April 12, 2024

Version 5

Warranty Extension: 2017-18 CR-V: DTC P0300, P0301, P0302, P0303, P0304, or P0172; Whirling Noise from Engine**Supersedes 19-037, dated April 29, 2022, to revise the information.****WARRANTY CLAIM INFORMATION**

REVISION SUMMARY

13. Remove the camshaft holder bolts, then remove the camshaft holders. To prevent damaging the camshafts, loosen the bolts as shown, two turns at a time.

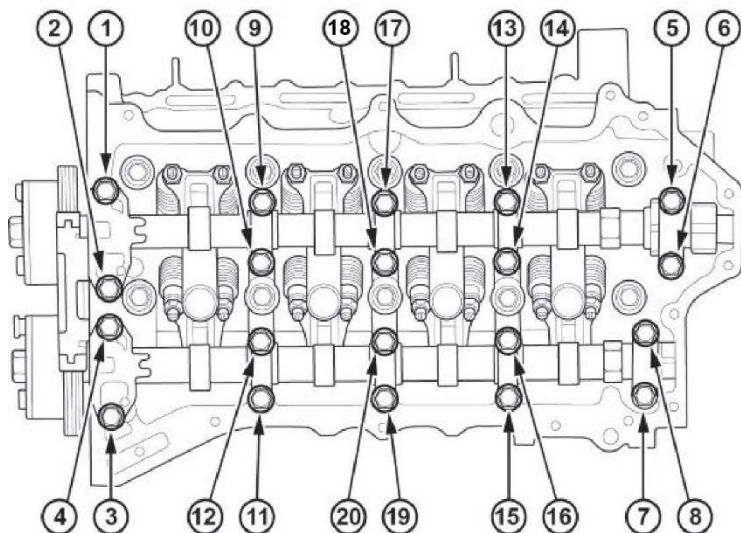
Under CAMSHAFT AND ROCKER ARM ASSEMBLIES REPLACEMENT PROCEDURE, an image in step 13 was revised.
